AIRCRAFT AND MAINTENANCE PARTS

**NORTH AMERICAN—REPLACEMENT OF FUEL SELECTOR SWITCH—P-51B,
P-51C, P-51D, AND P-51K**

Figure 1

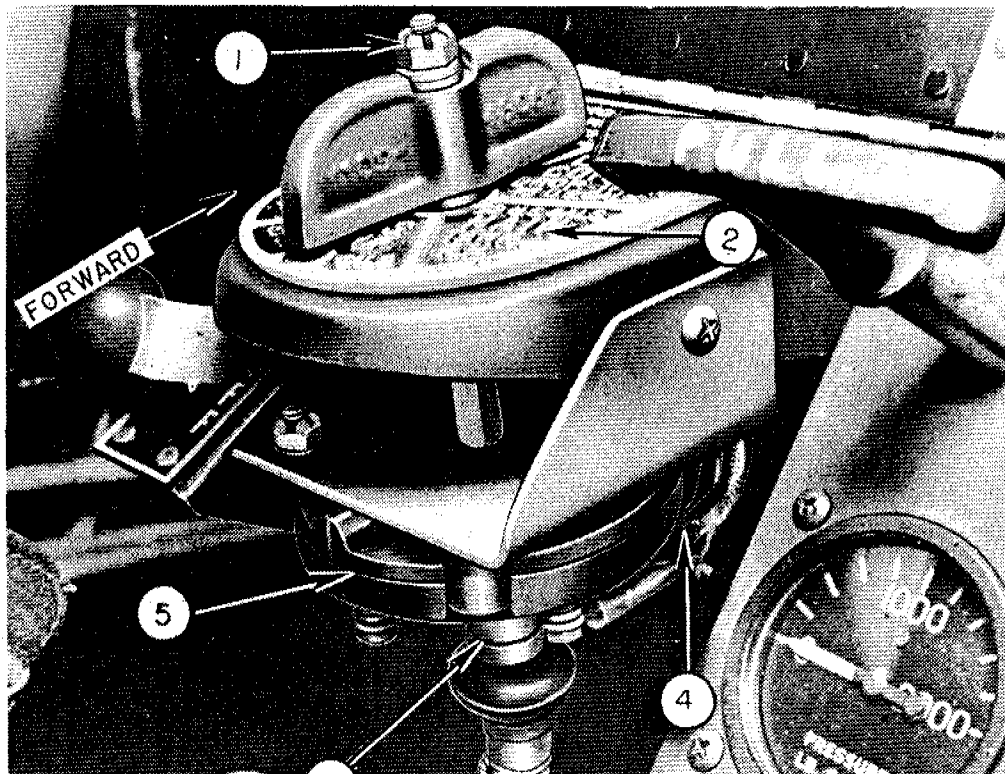
1. a. To provide a more reliable fuel selector switch, a switch of improved design will be installed on the following airplanes in accordance with the instructions contained in paragraph 2.

a. Locate the fuel selector switch in the pilot's cockpit. Remove the control handle by removing the nut and washer securing it to the rod. Remove the plastic dial from the switch bracket. (See figure 1.)

NOTE The improved type switch contained in either parts kit will be identified by red letters on the bottom of the switch. Letters on the old switch are white or yellow. On airplanes requiring two switches, the NA1 switch is installed on the top side of the bracket, and the NA2 switch on the lower side.

Figure 1

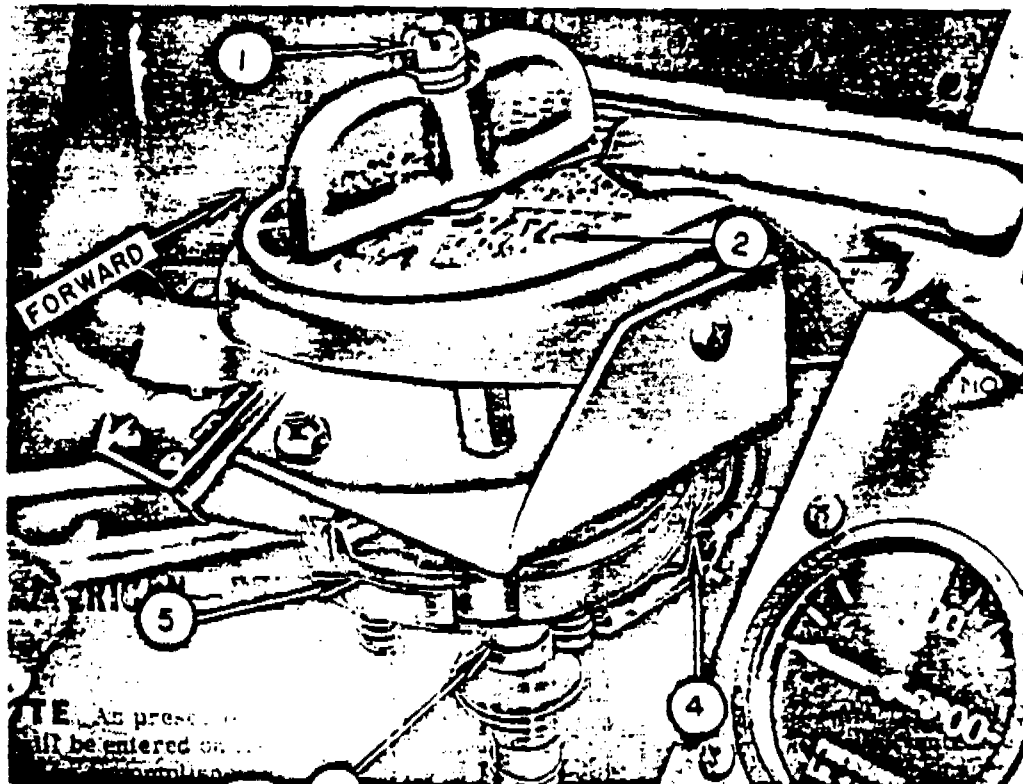
1. a. To provide a more reliable fuel selector switch, a switch of improved design will be installed on the following airplanes in accordance with the instructions contained in paragraph 2.

a. Locate the fuel selector switch in the pilot's cockpit. Remove the control handle by removing the nut and washer securing it to the rod. Remove the stic dial from the switch bracket. (See figure 1:)

NOTE The improved type switch contained in either parts kit will be identified by red letters on the bottom of the switch. Letters on the old switch are white or yellow. On airplanes requiring two switches, the NA1 switch is installed on the top side of the bracket, and the NA2 switch on the lower side.
